**Statement of Advisory Neighborhood Commission 6C
In Support of Appeal to the Board of Zoning Adjustment
Concerning Permit B2308873**

1. This appeal is taken against the Department of Buildings (DOB) and DOB’s Zoning Administrator, Kathleen Beeton.
2. ANC 6C appeals the issuance of permit B2308873 (“the permit”; copy at Attachment A), issued on February 1, 2024.

3. The permit and this appeal relate to 638 I (Eye) St. NE, aka square 857, lot 125 (“the Property”) in the RF-1 zone.
4. The Property’s owner of record is Kevin R. Chen, 638 I St. NE, Washington, DC 20002.

BUILDING SECTIONS

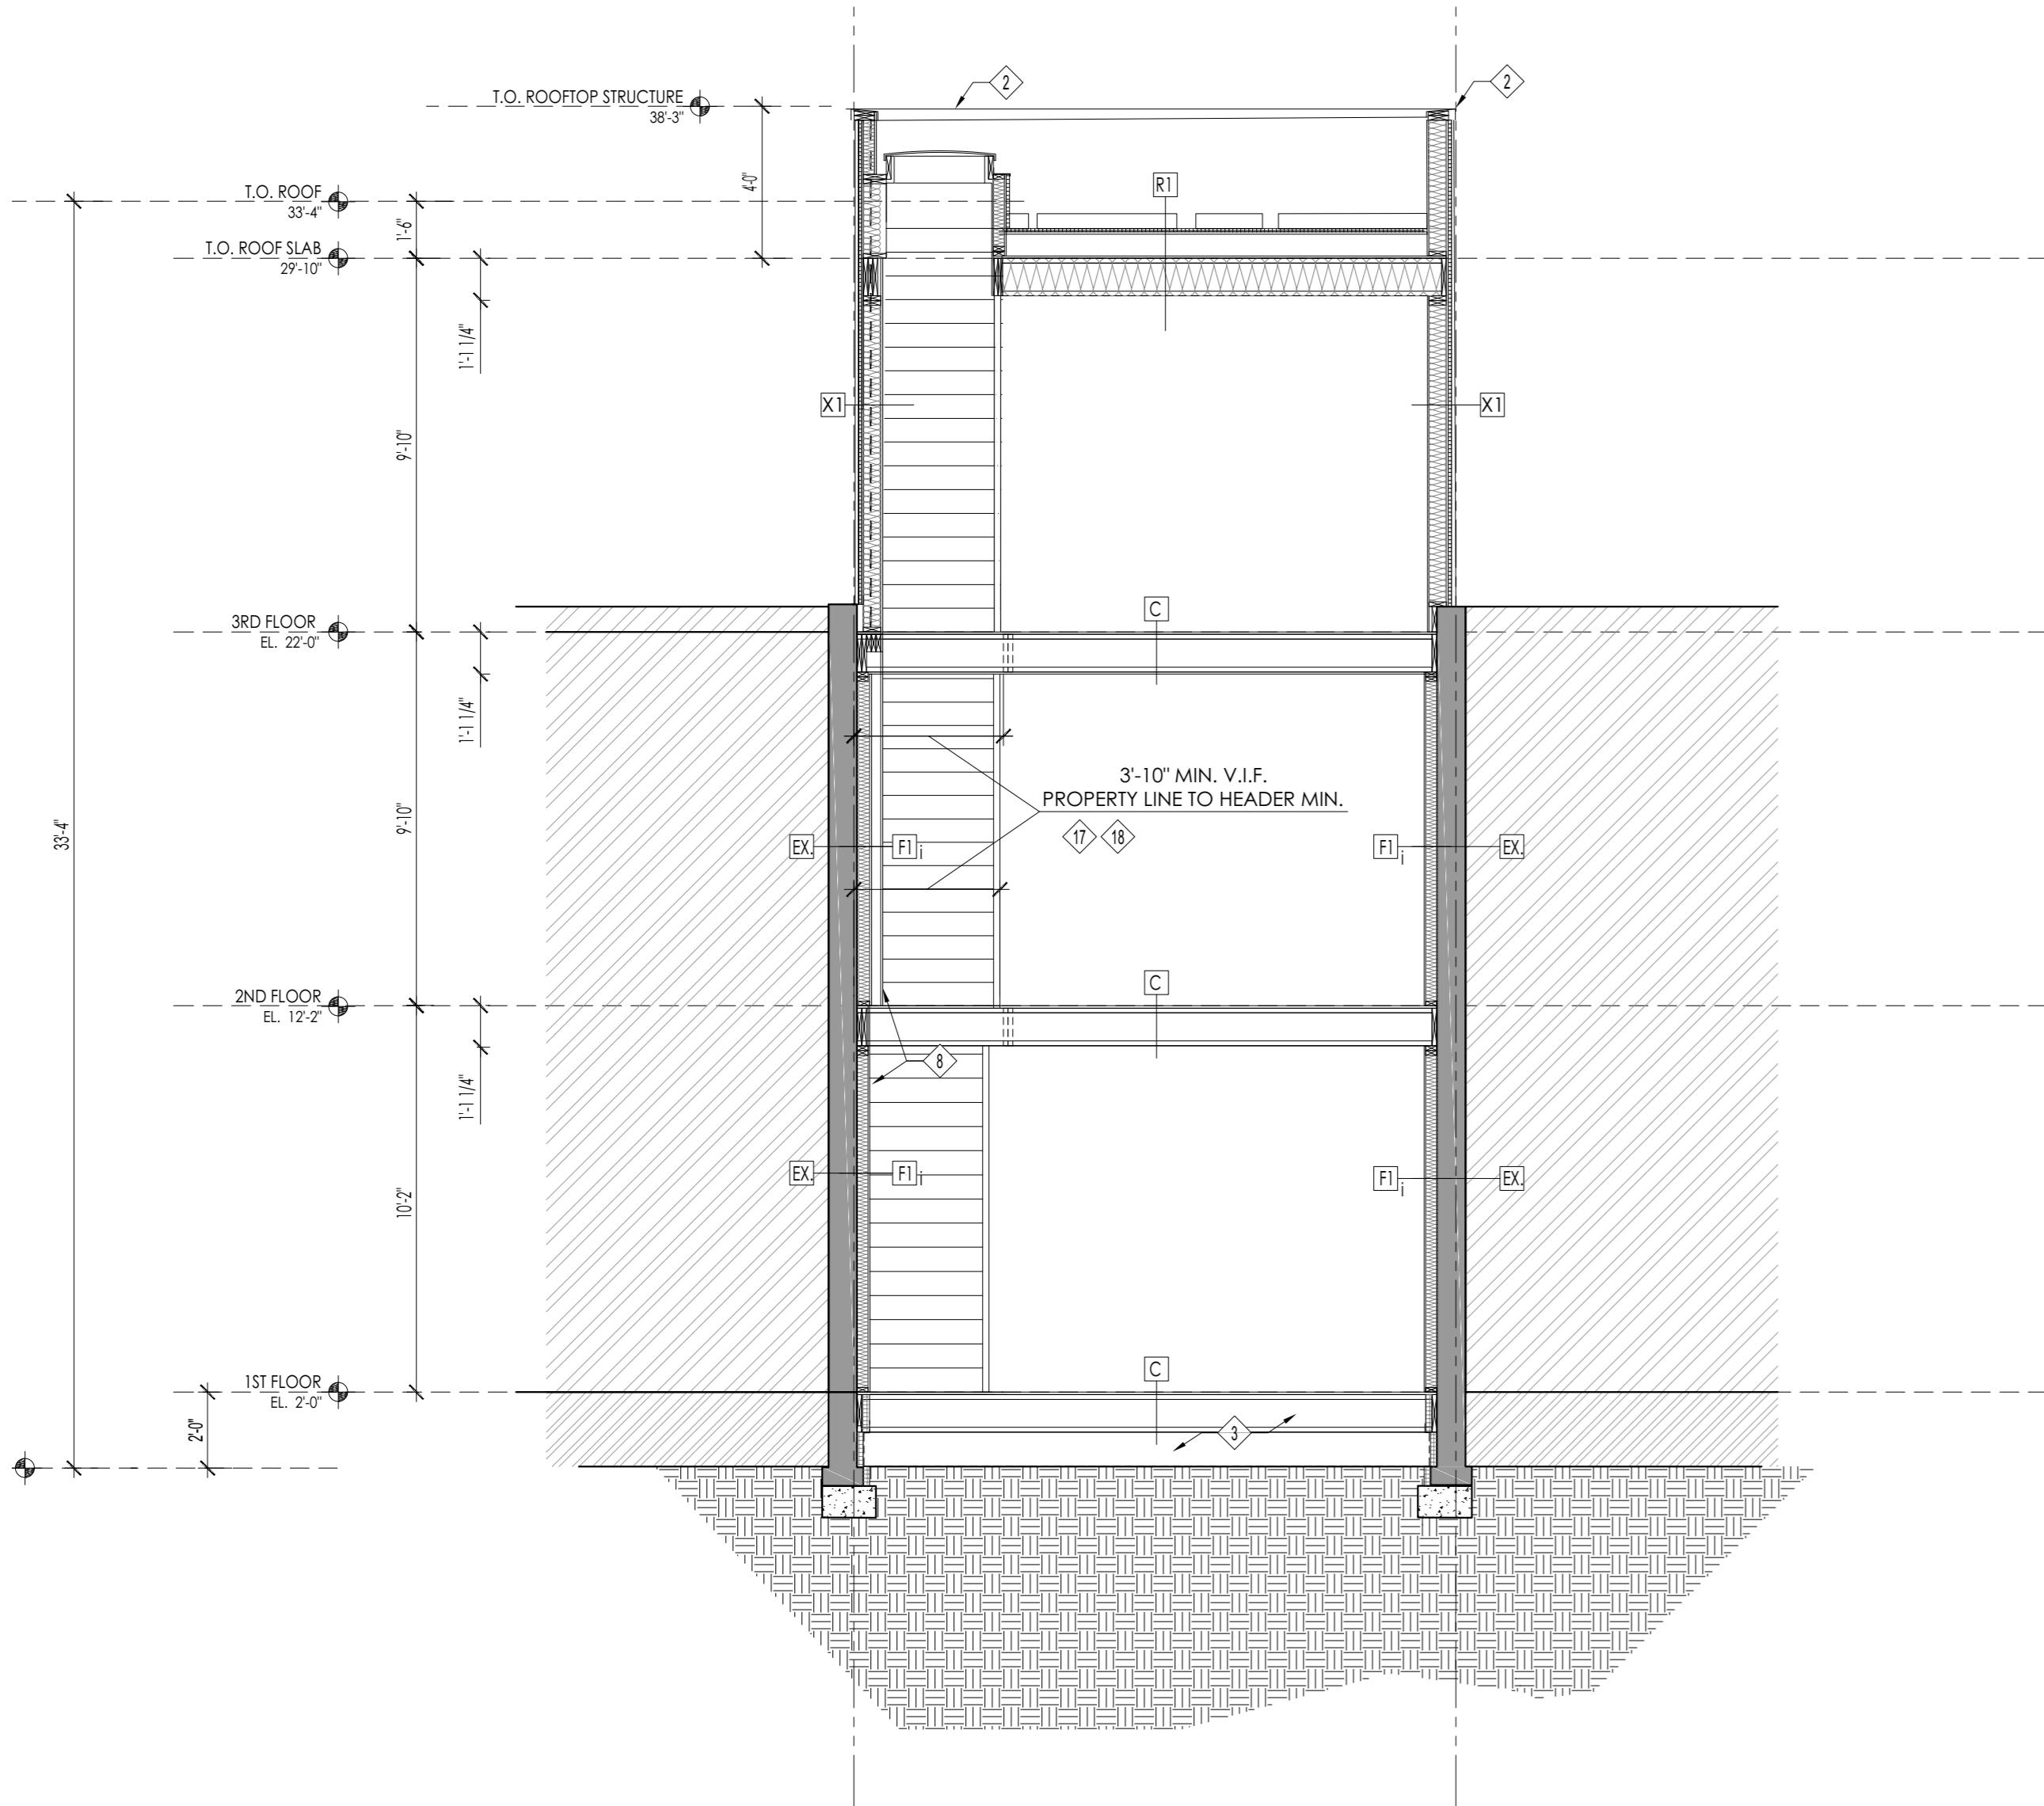
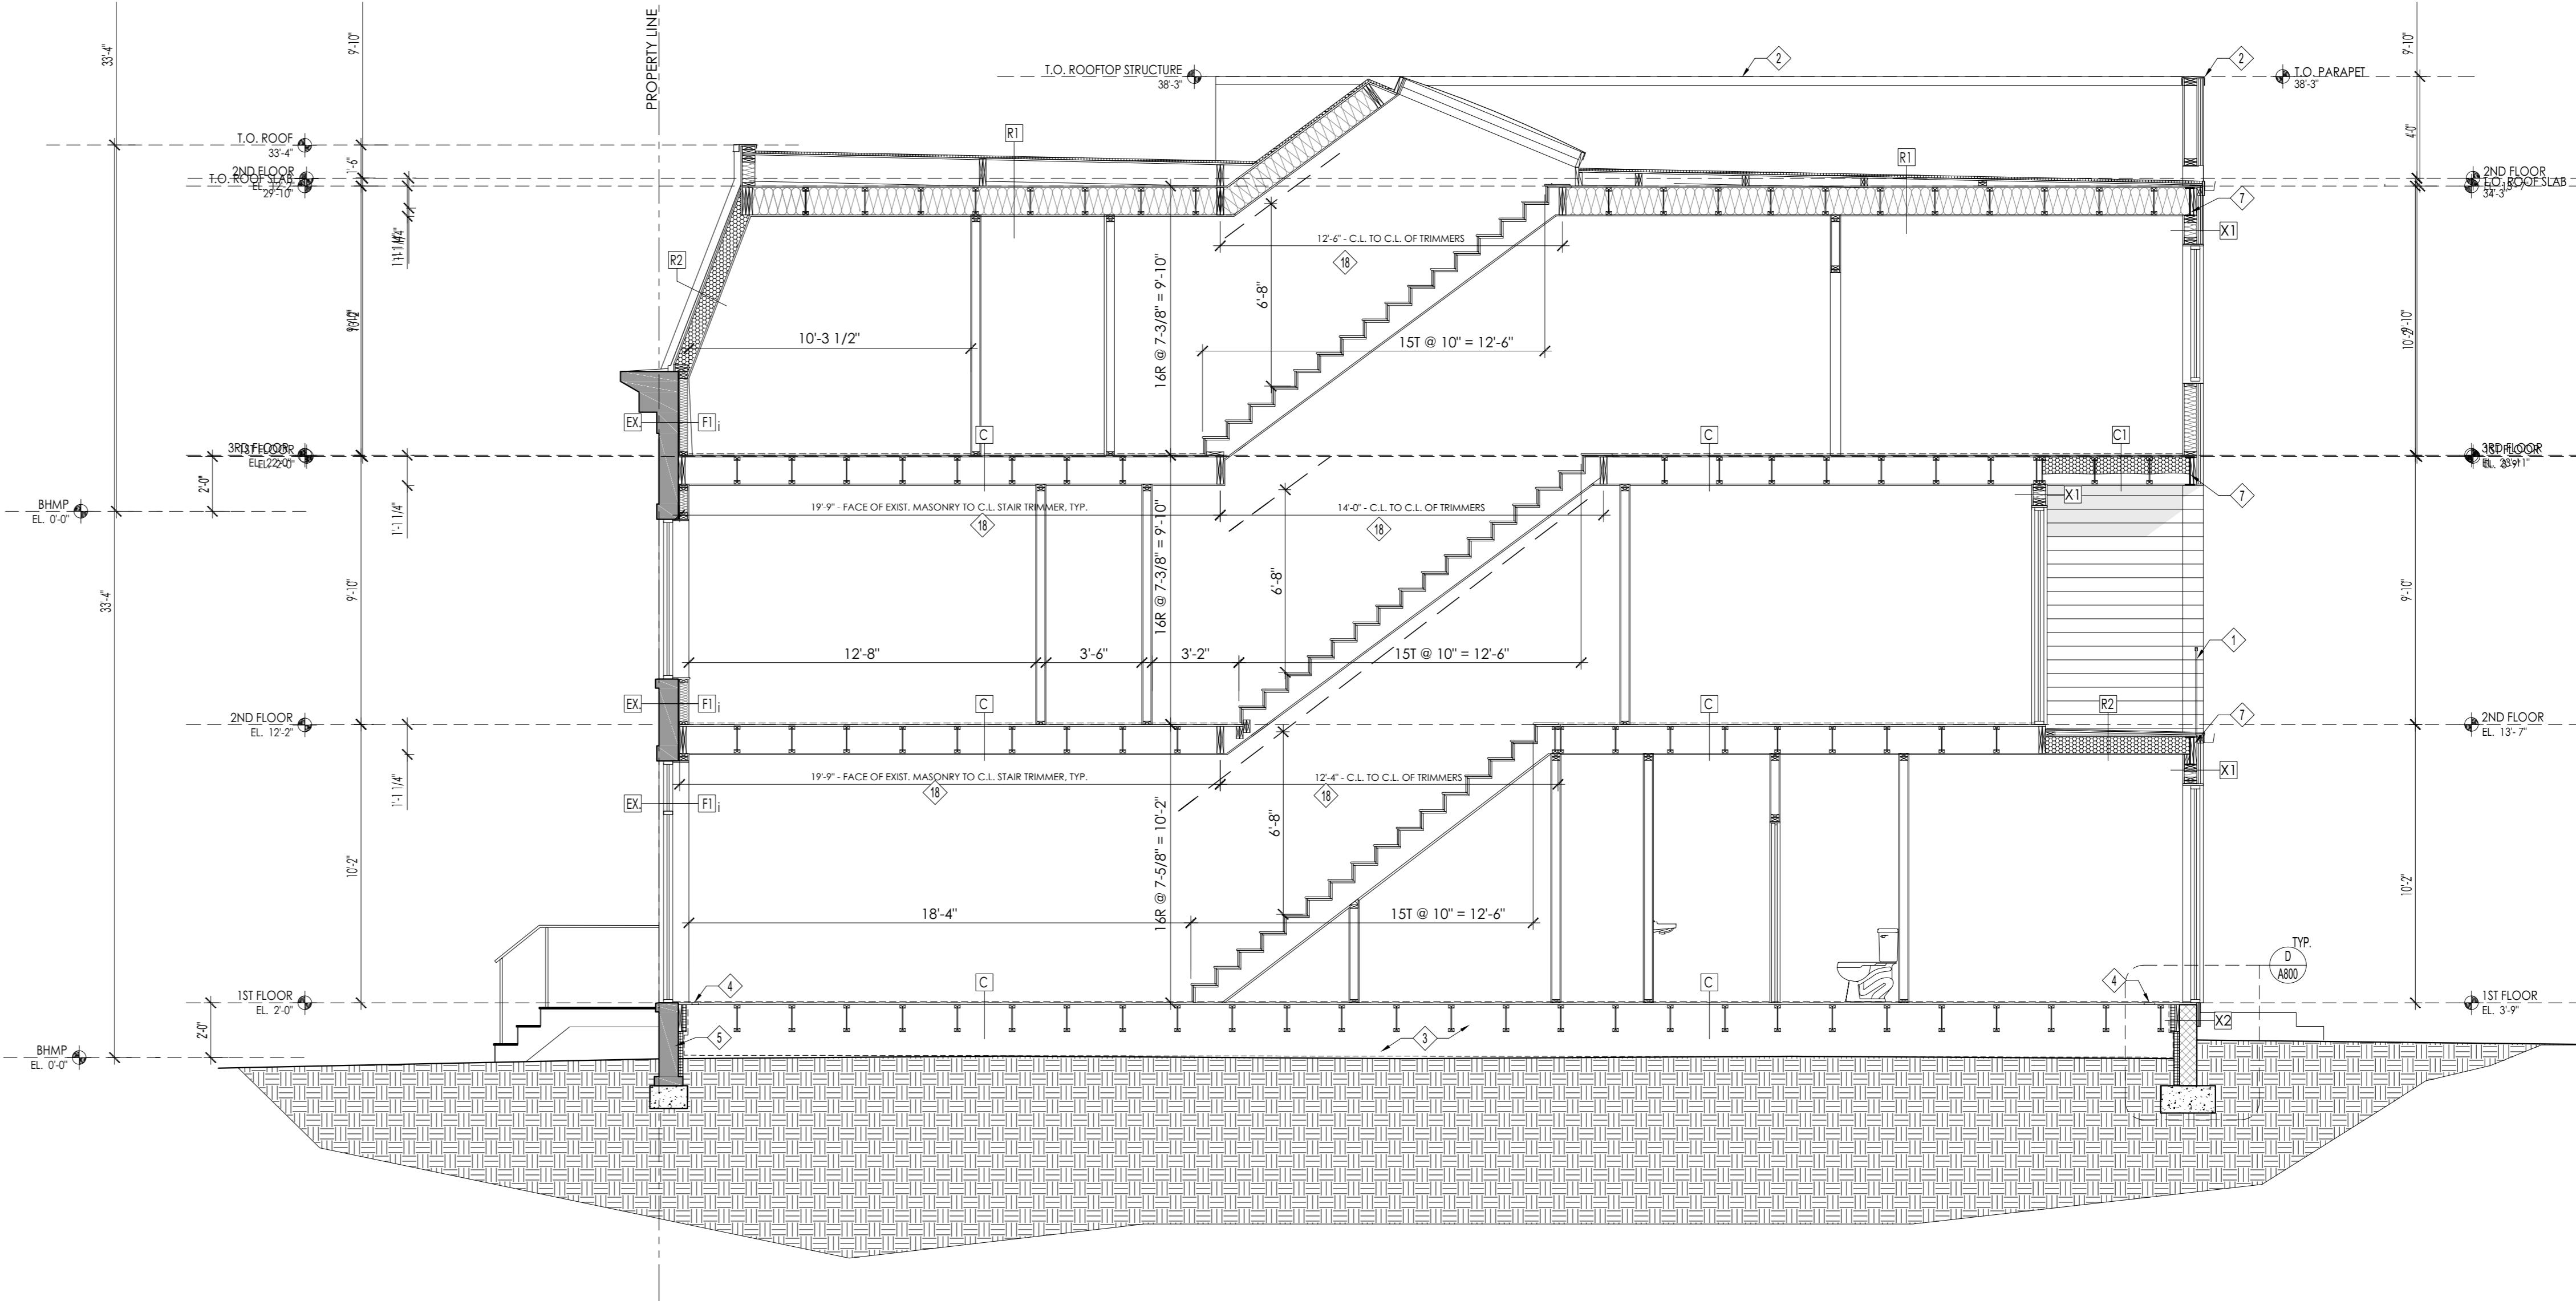
8. Specifically, the permit authorizes construction of an upper-floor addition directly atop an existing cornice—that is, above the cornice in the same plane with no setback.

Please accept this email as a challenge to the issuance of the above referenced building permit. The approved permit drawings are not consistent with the Zoning Administrator's Interpretation 7 regarding required setbacks from protected architecture rooftop elements.

The attached excerpt from the permit drawings depicts a rooftop addition that is coincident with the front facade and cornice, not set back 3 feet. A copy of interpretation 7 downloaded from the DOB website this morning is also attached for reference. Please review and, if you are in agreement, revoke the permit.

Consistent with the past practice under the former Zoning Administrator, a cornice is not a roof-top architectural embellishment and therefore a new addition may be constructed flush with an existing cornice.
